Site Address:
2 Kingfisher Close,
Kirkby,
L33 4DP

Drawing Title:
Proposed Isometric Views

Project No:	Drawing No:	Scale @ A1	Revision:
25.009	104	1 : 50	P01

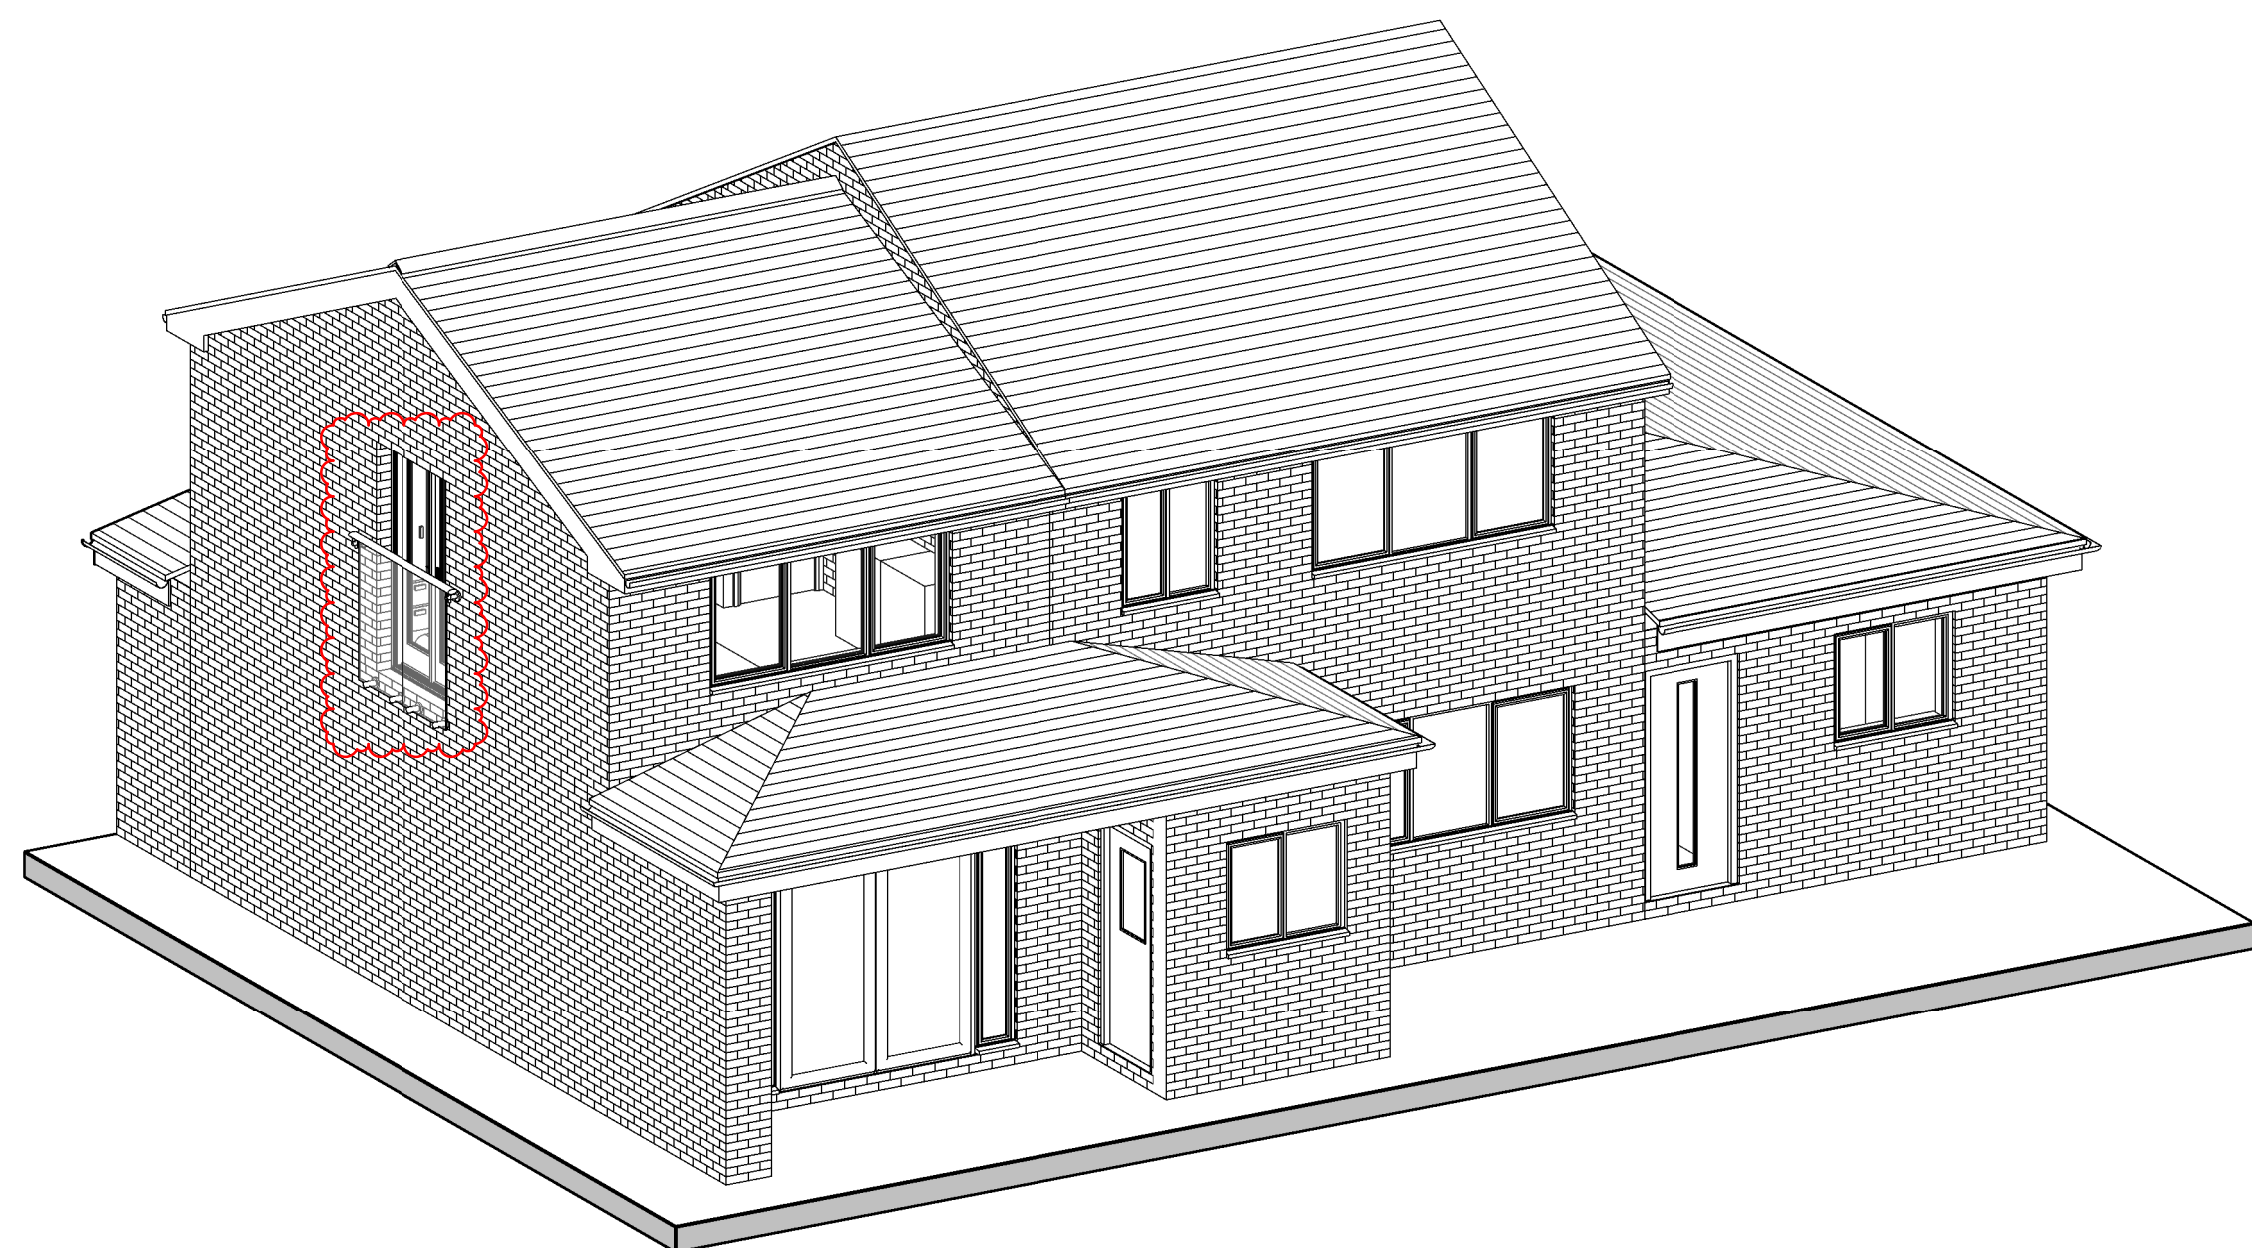
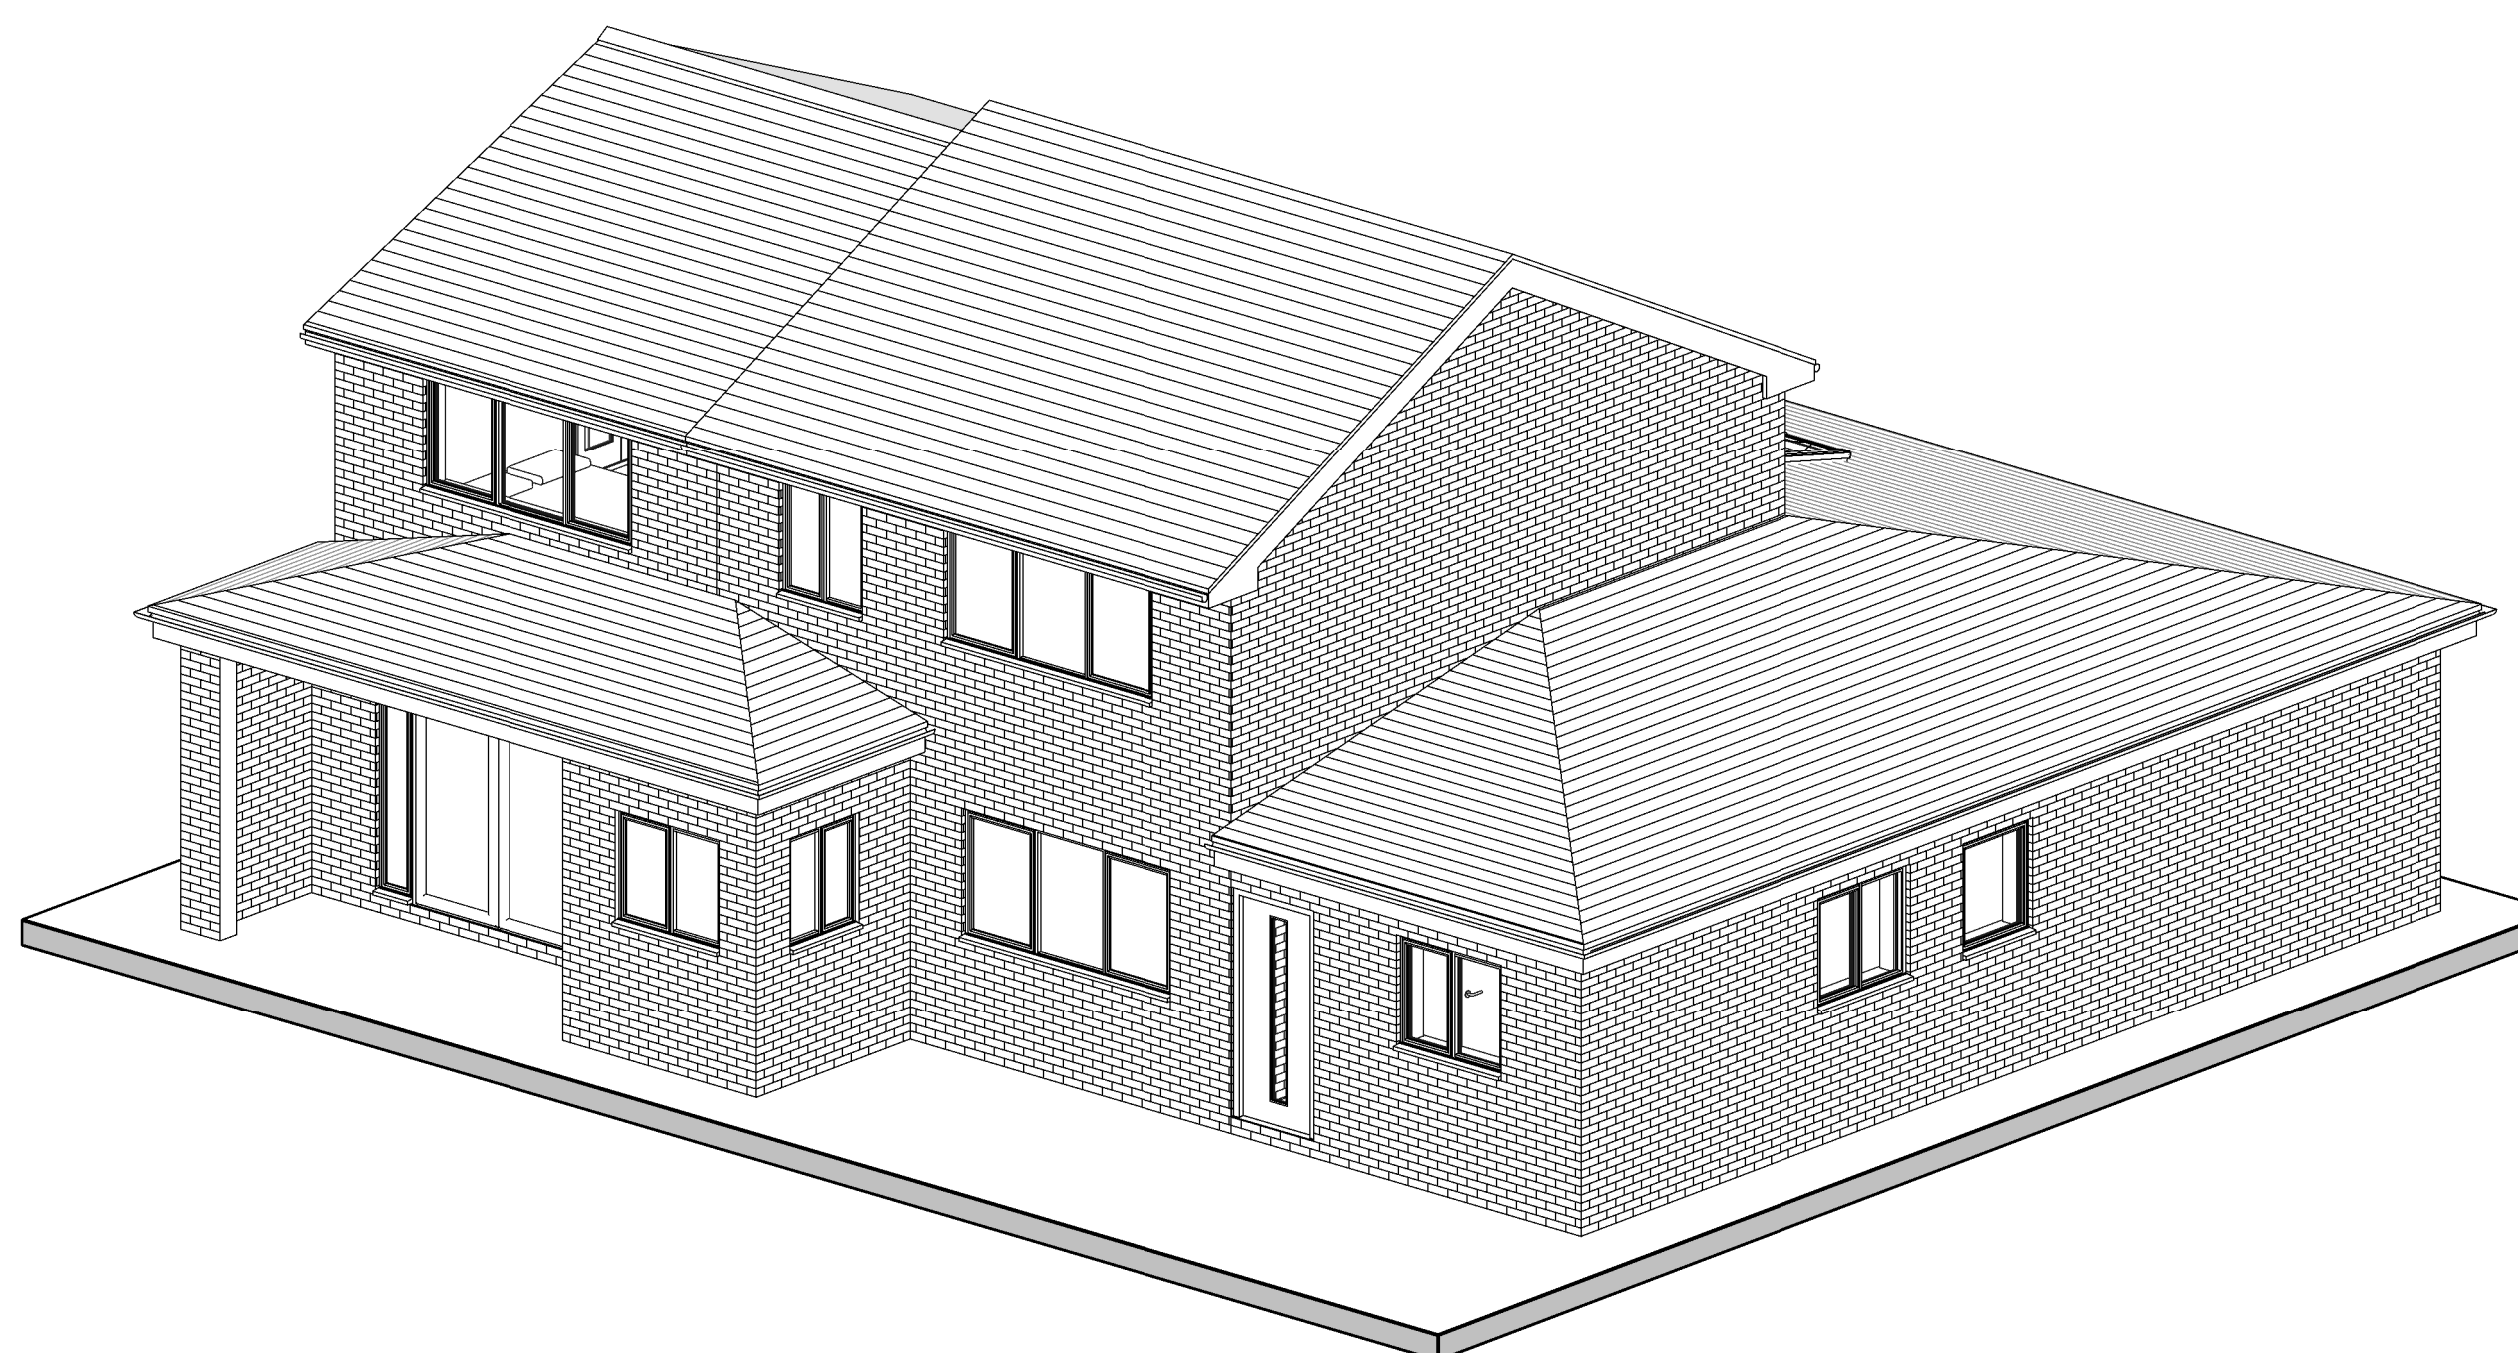
Rev	Description	Date
P01	Juliet balcony added to the (south-facing) side elevation. Submitted to Planning as a Non-Material Amendment application. Revised as clouded.	13.02.2026
